# A303 Sparkford to Ilchester Dualling Scheme TR010036

## 9.20 Responses to Action Points for Deadline 5

**Responses to Action Points for Deadline 5**

## **Appendix B – Signage Strategy Drawings**

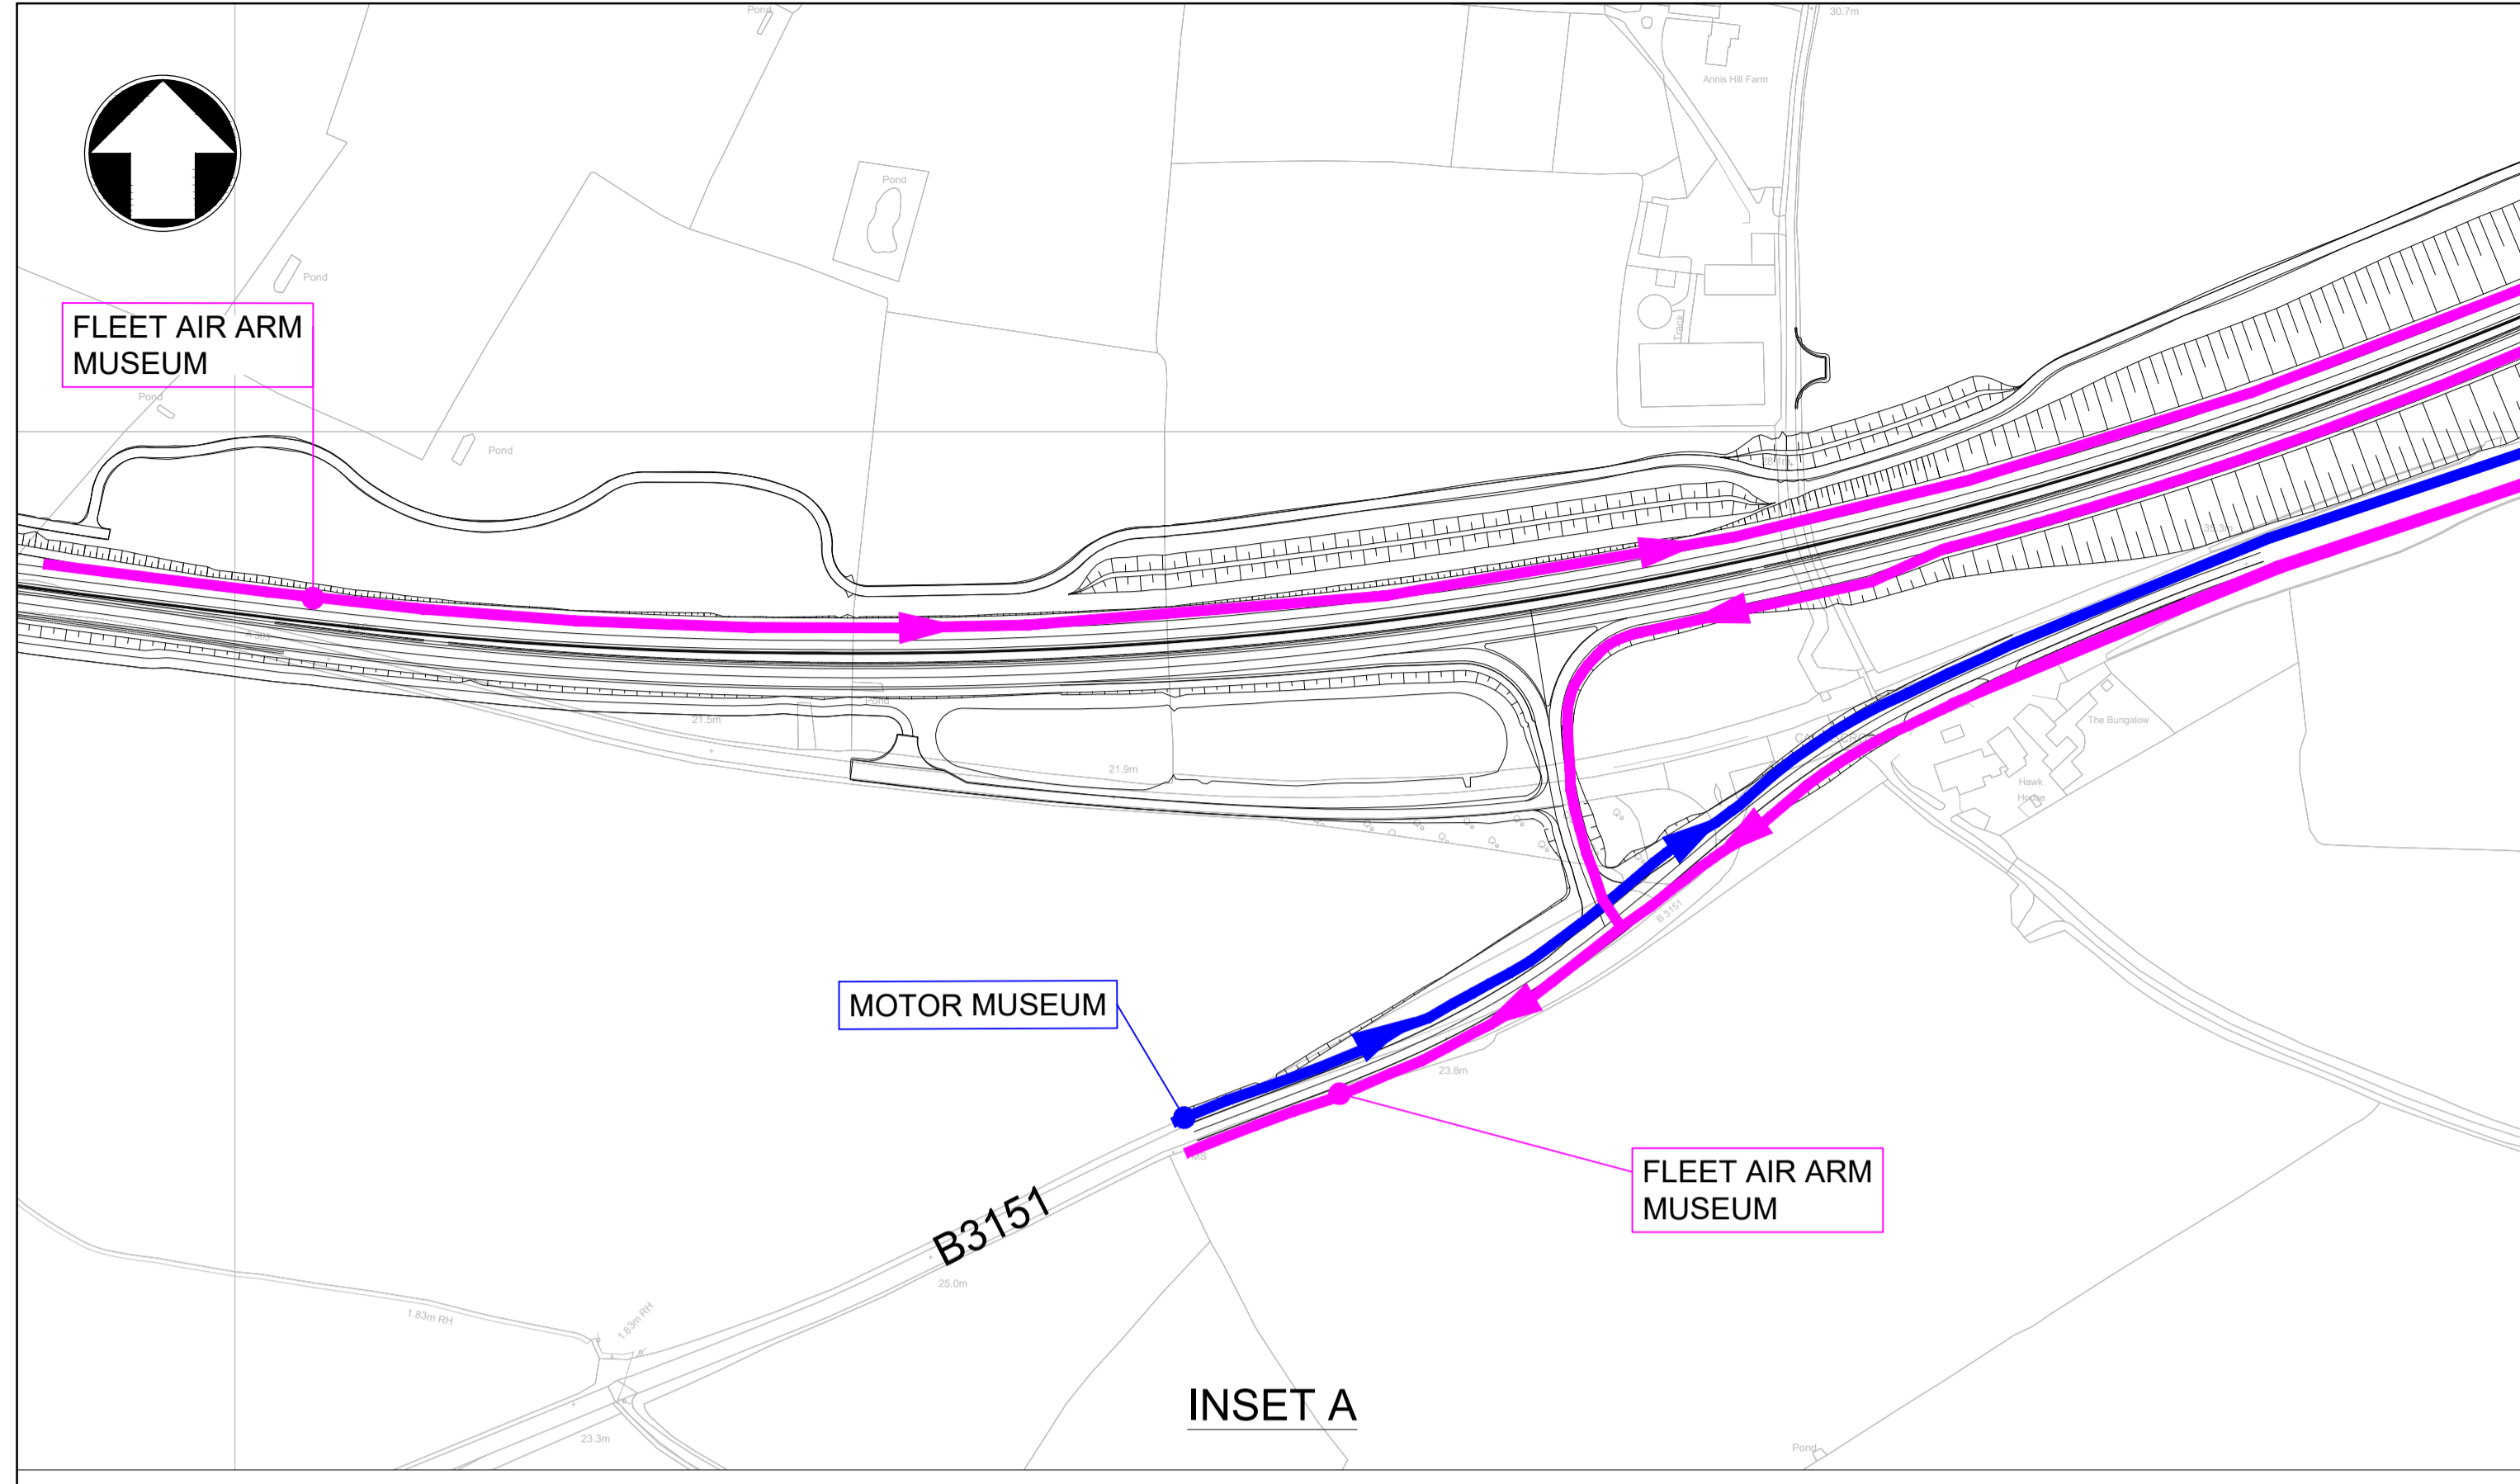
2.1.57 Action Point 43 requests: *Confirmation of how Signage Strategy is to be delivered under the dDCO.*

The tourist signage strategy is shown in drawing HE551507-MMSJV-000-HGN-DR-CH-0206 (Appendix B of this report). The destinations included in the strategy are the Fleet Air Arm Museum, Motor Museum and Long Hazel Camp Ground.

The Fleet Air Arm Museum is currently signed along the A303 eastbound from as far as Junction 25 of the M5. The museum is also signed westbound from the existing Hazlegrove junction, including the A359 northbound approach to the roundabout. The signage strategy reflects this, providing signage from the A303 eastbound at Downhead and the A303 westbound at Camel Cross. The signage from the A359 northbound approach to Hazlegrove is also maintained, although in order to rationalise signage at the westbound approach the museum is not signed on the A303 westbound approach to Hazlegrove.

Haynes International Motor Museum (signed as 'Motor Museum') is currently signed from the B3151 approach to Camel Cross and the A359 northbound approach to Hazlegrove. This is maintained in the proposed strategy.

The motor museum is also currently signed on the A303 westbound approach to the Hazlegrove junction. However this has been removed from the proposed strategy in order to rationalise signage on the nearside westbound verge, on reflection of the fact the westbound drivers are actually directed to leave the A303 at the previous junction (South Cadbury).

The Long Hazel Campground appears to have an advance sign on the A303 eastbound and westbound approaches to the Hazlegrove Roundabout, and on the A359 exit from the roundabout itself. The signs on the existing A303 approach will not be retained although the campground will be signed from the Hazlegrove roundabout onwards.
